Project: **Renovation to Clarington Emergency & Fire Services Station 1**
ward99 architects Project No. 24008

RE: **Consultant Addendum No.1**

STRUCTURAL ADDENDUM No 1

Re: Renovation To Clarington Fire & Emergency Services Station 1
The Corporation of the Municipality of Clarington
2430 Durham Regional Hwy 2, Bowmanville, ON, L1C 6C8

drawing no.
S-1

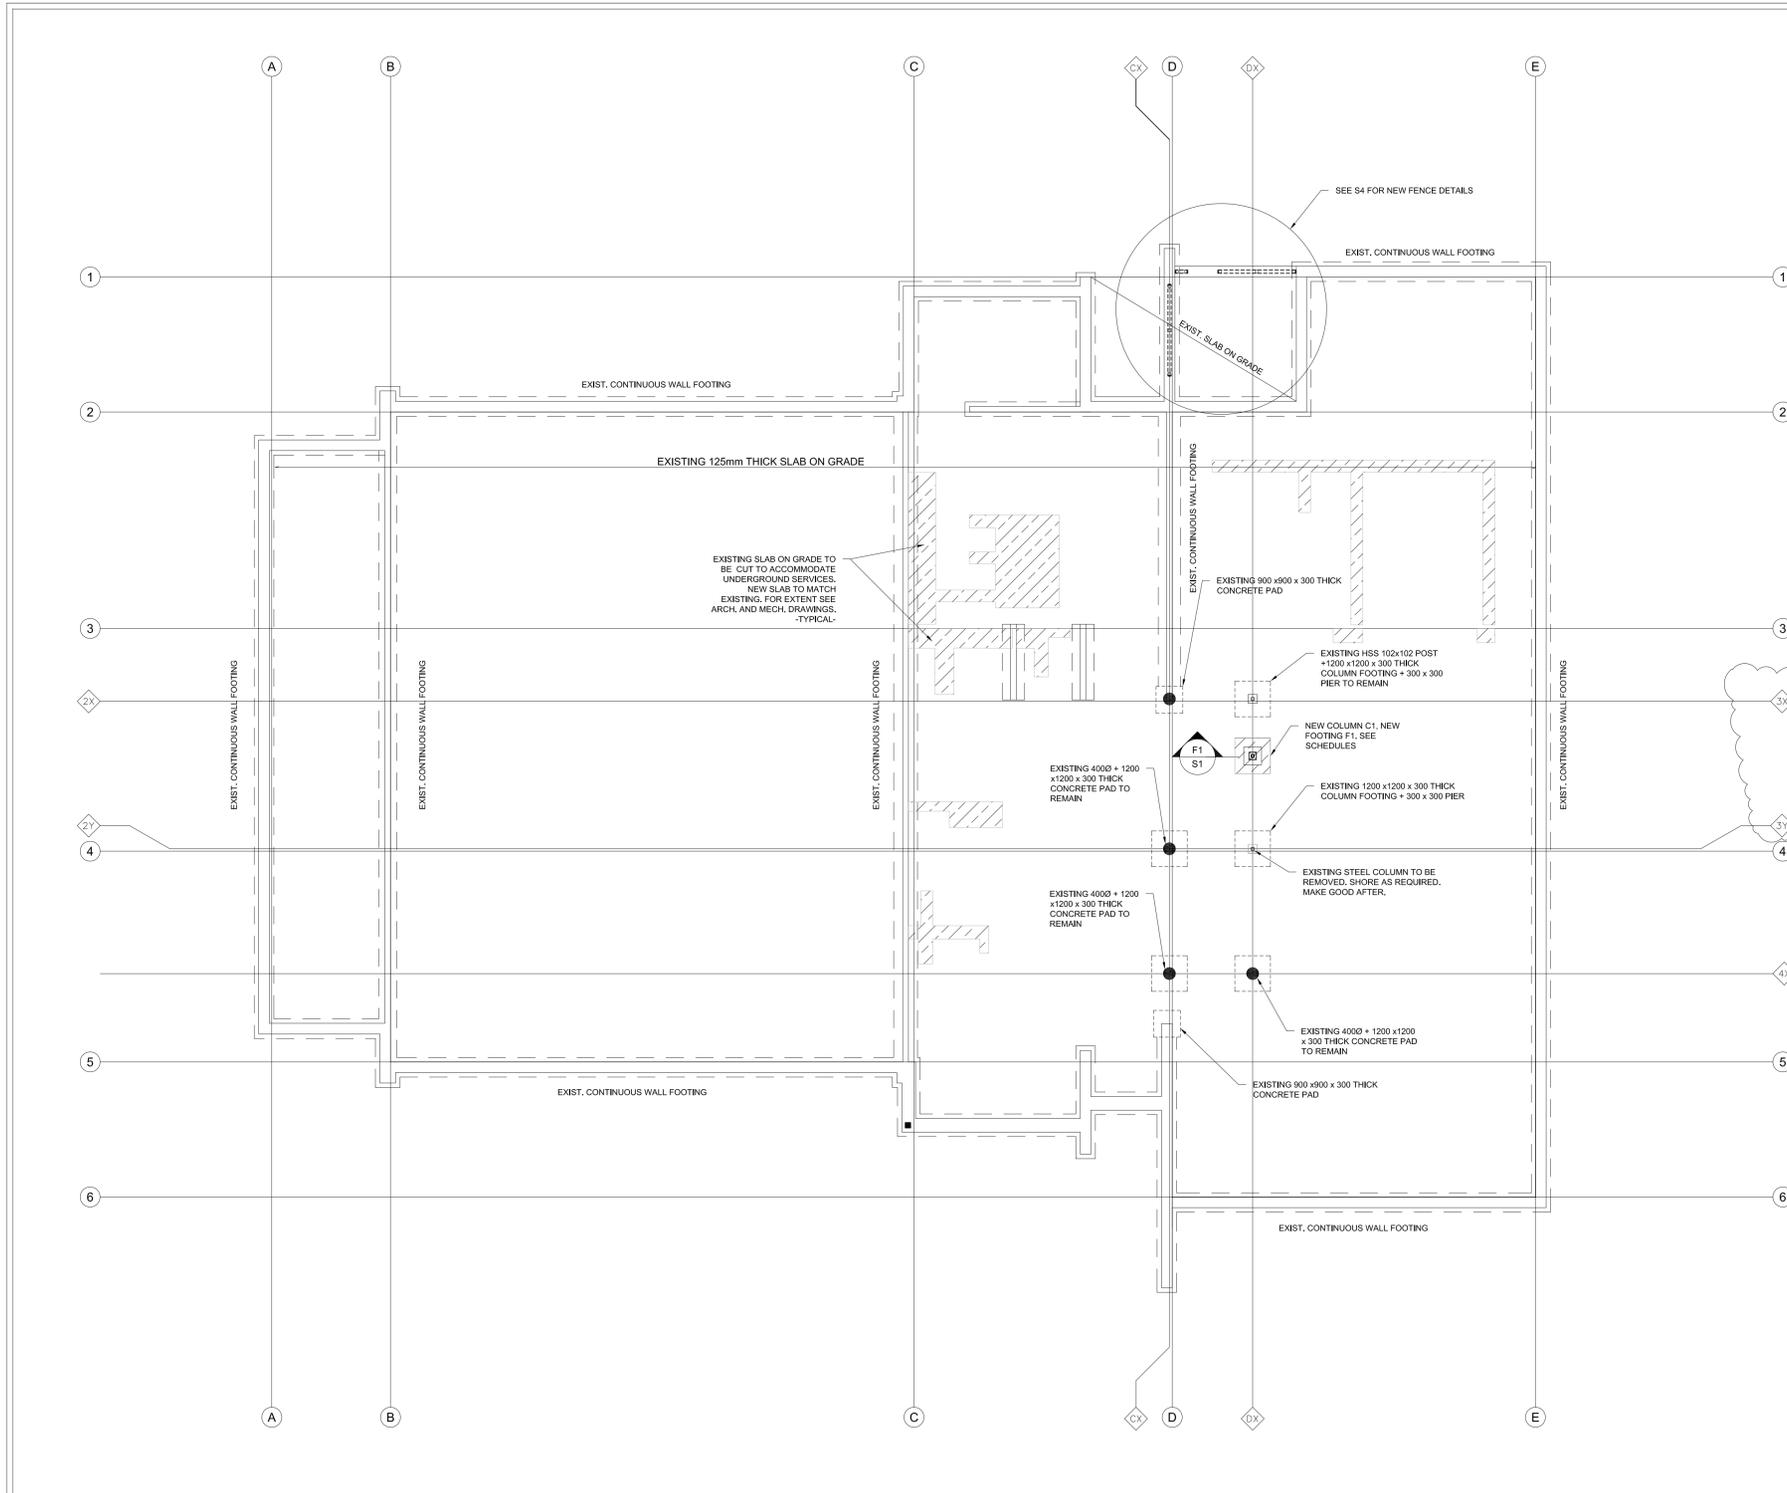
DRAWINGS S1, S2, S4:

1. Refer to note in the bubble in the typical detail 3/S1. The note is modified to specify that the bars drilled in existing slab to be epoxy grouted.
2. Grids are updated to match architectural drawings. See bubbles in plans 1/S1 and 1/S2.
3. See bubble in 1/S2, close to New WR Entry 123A. The nib wall is removed to match with the architectural drawings.
4. Refer to bubble in the fence details 2/S4, 3/S4 and 4/S4. The type of the epoxy for the drilled bolts is defined in the note. The note is typical and the same for the three sections. Use the described adhesive epoxy or equivalent.
